UNITED STATES PATENT AND TRADEMARK OFFICE

APPLICATION NO.	FILING DATE	FIRST NAMED INVENTOR	ATTORNEY DOCKET NO.	CONFIRMATION NO.
10/628,368	07/29/2003	Praba Kharan Baptist	2993-479US RM/JR/mp	5159
32292	7590	01/18/2006	EXAMINER	
OGILVY RENAULT LLP (PWC)			COLLINS, TIMOTHY D	
1981 MCGILL COLLEGE AVENUE			ART UNIT	
SUITE 1600			PAPER NUMBER	
MONTREAL, QC H3A 2Y3			3643	
CANADA			DATE MAILED: 01/18/2006

Office Action Summary	Application No.	Applicant(s)	
	10/628,368	BAPTIST ET AL.	
	Examiner	Art Unit	
	Timothy D. Collins	3643

DETAILED ACTION

Fig. 6

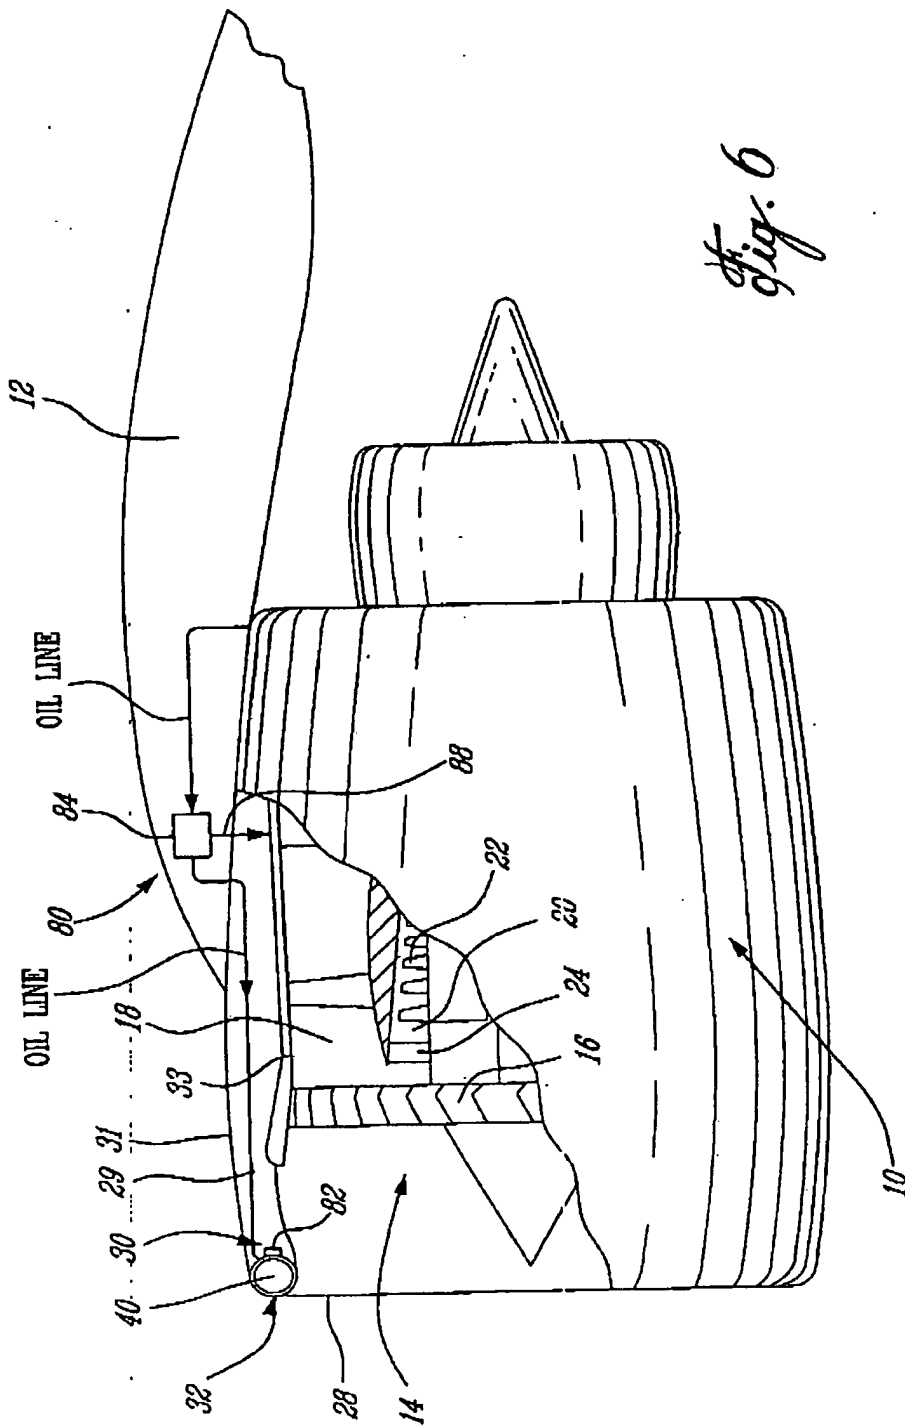
The drawings were received on 11/10/05. These drawings contain new matter and will not be entered.

New corrected drawings in compliance with 37 CFR 1.121(d) are required in this application because the new figure 6, which has not been seen previously contains new matter. The part number 82 is shown to be attached to the conduit 40 and this is the new matter. The examiner suggests that the applicant use a "black box" method to show the sensor. For example, the applicant can move the positioning of the part 82 to somewhere along the arrows from the part 84 to the part 40 and show the location more abstractly, because the applicant had not previously provided any details of the position of the sensor 82. Applicant is advised to employ the services of a competent patent draftsman outside the Office, as the U.S. Patent and Trademark Office no longer prepares new drawings. The corrected drawings are required in reply to the Office action to avoid abandonment of the application. The requirement for corrected drawings will not be held in abeyance.

Eng Not Approved, D.O. 11/11/06
